**Title:** Updated Headlamp Fasteners

**Applicability:** MY 2025 Revero, Revero GT and GTS, GS-6 vehicles

**Purpose:** Updated fasteners for headlamps

Fig 1a

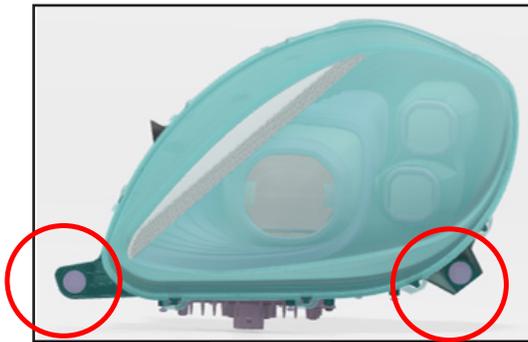
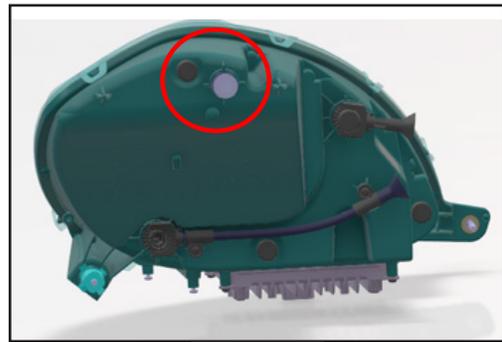
The Headlamp fasteners have been updated. These new parts provide a better hold on the headlamp mounting tabs. When replacing headlamps, replace the fasteners with C140200707200 Screw-Pan-head SEMS 6-Lobe M6 x 1.0 x 45.0 PC8.8. (3 fasteners per headlamp Fig 1a and 1b)

Old style fastener Fig 2a and 2b

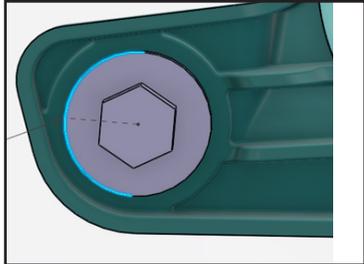
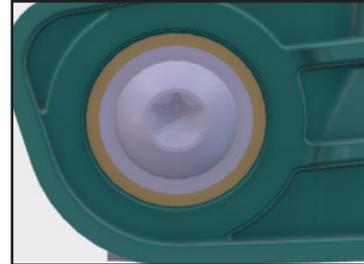
New fastener Fig 3a and 3b
